Consent Agenda Item (Action Item): Consider/Approve PR#29 for Floyd Central High School.

FLOYD CENTRAL HIGH SCHOOL CHANGE ORDER REVIEW

Work Changes Proposal Request

PROPOSAL REQUEST NUMBER: 029

OPTION #1 - CLASSROOMS & LABS

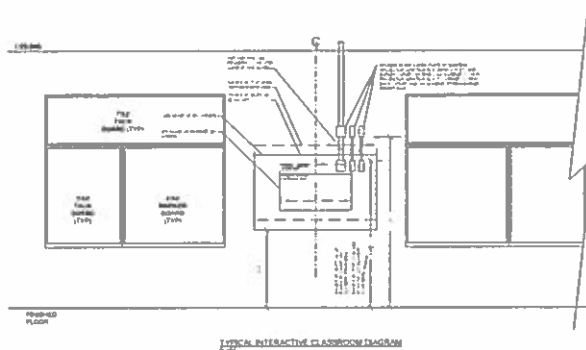
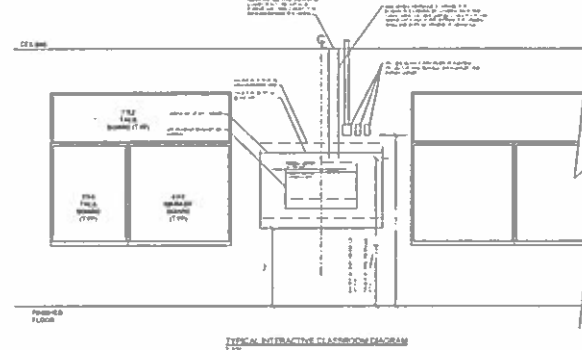
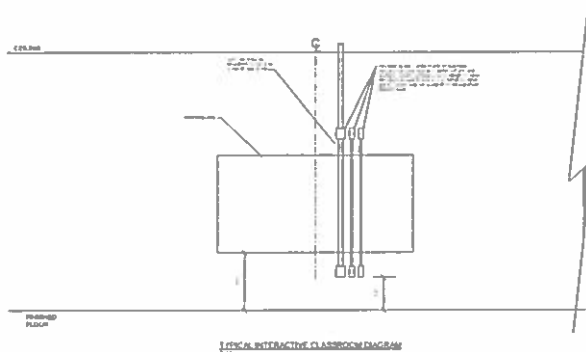
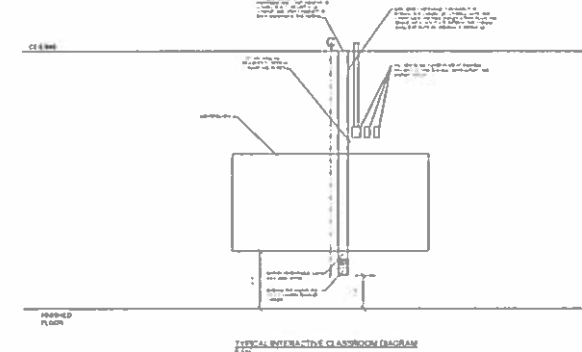
Provide itemized pricing for all labor and material for all work required for this proposal request. Contractor shall provide two prices to relocate wall-mount projector utilities per detail Sheet E7.7. One price shall be to perform all work and conceal conduit, patch and repair wall to like new condition. Second price shall be to perform work and provide surface mount wiremold as required to relocate utilities. Refer to Sheets 1, 2, ESK-2 and Sheet E7.7 for additional information.

History/Background: This PR is a change requested by the district to add instructional boards in every classroom. The recommendation is for option 1 which will run conduit down the walls in a professional manner. The committee recommended this change due to the numerous windows in the building which makes projectors harder to use and the functionality of the boards. This price change is only to run data/electric to the location in each room.
